Access Compliance Report

Public Rights-of-Way

(Curb Ramps)

Intersection ID: 24741	Main Street: CHOATE_CR	Cross Street: SMITH_RD	Location: SE
ADA ID: FB6221052359	Ramp Type: PerpDiag	Initial Pass/Fail: Fail	Overall Compliance: No
			Severity Score: 13.75

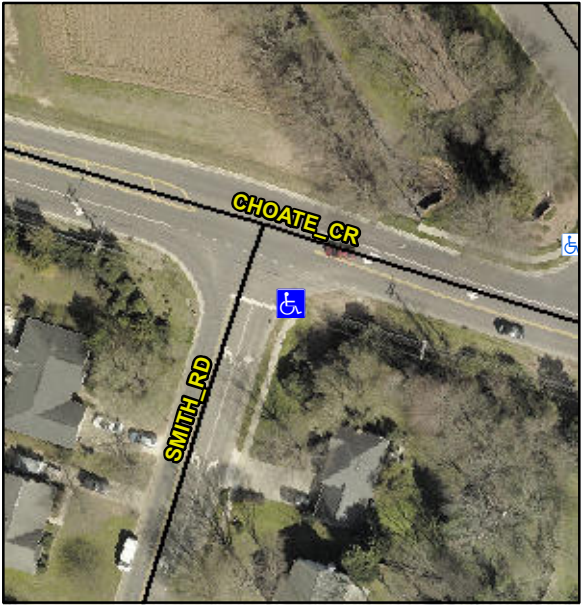
Codes/Mitigation Info/Possible Solution			Field Measurements/Component Compliance		
 <p>Street 1 Name: CHOATE CR</p> <p>Stop Condition-Street 2: None</p> <p>Street 2 Name: SMITH RD</p> <p>Stop Condition-Street 1: StopSign</p>	Possible Solutions:		Compliance	Description	Data
	Remove & Replace Curb Ramp With Two New Directional Ramps or Equivalent.		N/A	Ramp Length (in)	48.0
			Yes	Ramp Width (in)	48.0
			N/A	Flare Type LT	N/A
			N/A	Flare Slope LT (%)	N/A
			N/A	Flare Traversable LT?	N/A
			N/A	Landing Length (in)	N/A
			N/A	Landing Width (in)	N/A
			N/A	Landing Slope (%)	N/A
			N/A	Landing X Slope (%)	N/A
			N/A	Landing Curb? (Y/N)	N/A
			N/A	Shared Landing?	N/A
			N/A	Gutter Ponding?	N/A
			N/A	Gutter Lip Ht (in)	N/A
			N/A	Painted X Walk1?	No
				X Walk 1 Direction	To NE
			N/A	X Walk 1 Width (in)	N/A
				X Walk 1 Slope (%)	1.7
				X Walk 1 X Slope (%)	2.4
			N/A	Ramp inside XWalk1?	N/A
<p>Surveyor Notes:</p> <p>N/A</p> <p>PROW/ADA:</p> <p>Not Found, R304.2.2, R304.5.3</p> <p>Total Cost: \$ 3200.00</p>			N/A	Flare Type RT	N/A
